SUPPLEMENTARY PAPER A – TIDAL FLOWS AROUND PORT RAMSGATE

Response to proposals in the Levelling Up Fund Bid for Green Port Ramsgate

Produced for Ramsgate Regeneration Alliance 10/09/21

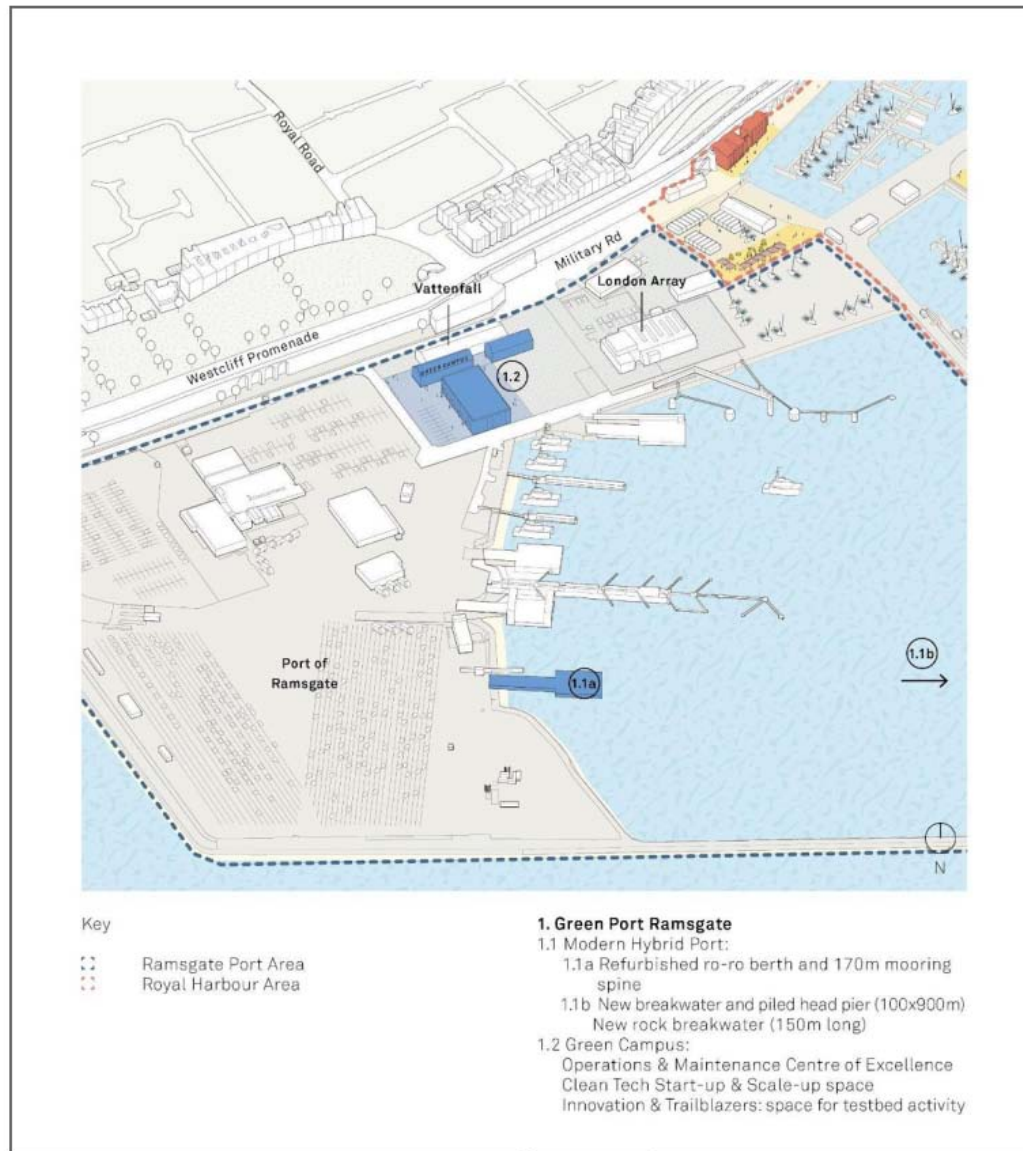
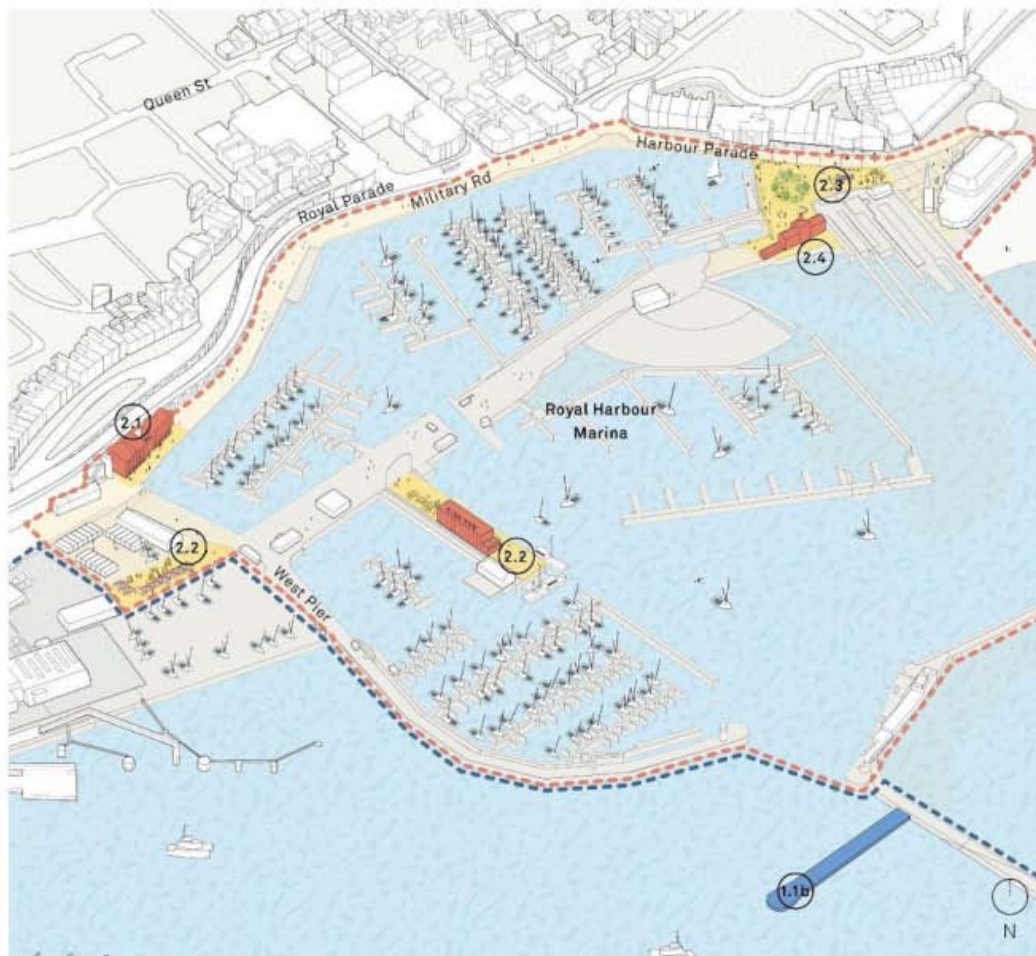
“Looking at the port plan that shows a 150m breakwater abutting the eastern breakwater 1.1b I cannot believe that any planner can be stupid enough to build there. it will do no good whatsoever the swells will still roll into the terminal bringing sand and when it encounters that 1.1b will swing into the Royal harbour just as it does now around the east pier, head, this will make the sand problem worse.”

1. Green Port Ramsgate

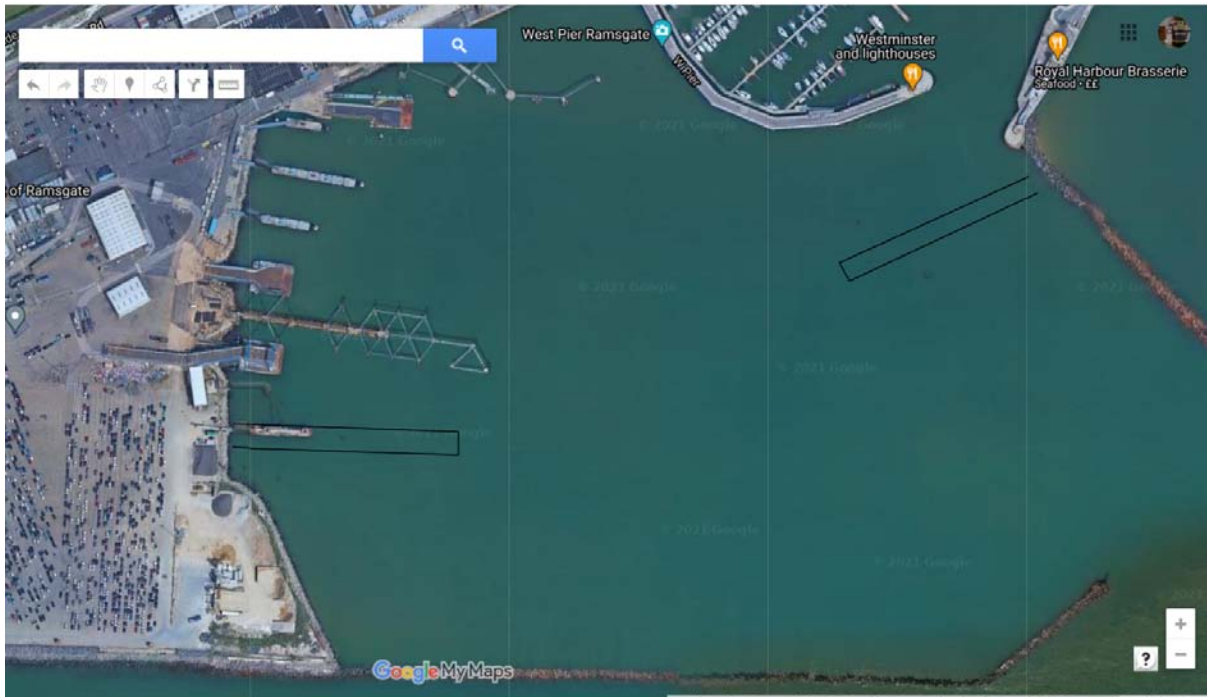
- The mock up satellite map page 4 above shows the scale length of the proposed breakwater; 1.1b of Annex A. The orientation is approximate.
- This breakwater will present a serious problem for ships manoeuvring in the port
- When entering and approaching any of the berths, (2, 3, 4 and 5) in any strong or gale force wind from NorthEast round to East, ships will want to stand well upwind – ie well to the north – before making a controlled descent into the berth.
- On departure from any of these berths, ships will need to turn through 180 degrees before leaving the port and entering the Approach Channel. This involves swinging the stern of the ship through the wind – with winds in the northeast quadrant that means swinging with the stern to the north. The proposed breakwater would make this manoeuvre difficult

- Silt is carried into the port on the tide. If the proposed breakwater is built this silt will build up against the seaward side of it.
- In addition, the orientation of the breakwater will deflect the inflowing tide (and therefore the silt) in a south westerly direction, thereby causing even greater siltation in the area of No 4/5 Berth.

Green Port Ramsgate 1.1a – Refurbished ro-ro berth and 170 metre mooring spine
 Green Port Ramsgate 1.1b – New rock breakwater (150m long)

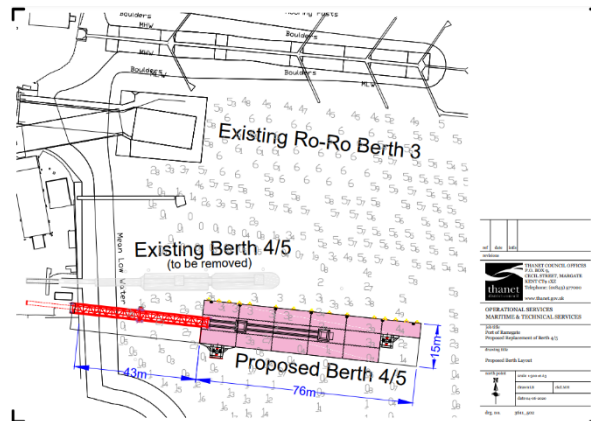
It is foolhardy in the extreme to attempt to mitigate the effects of tidal siltation without first modelling the proposed solutions. Previous attempts to use breakwater extensions for this purpose have singularly failed yet still more breakwaters are being proposed without any firm evidence that they will be effective. The port of Calais spent most of the last decade modelling the tidal flow around the area of the port extension to determine the most effective configuration of breakwaters; this should be a lesson for those proposing changes to the port of Ramsgate.
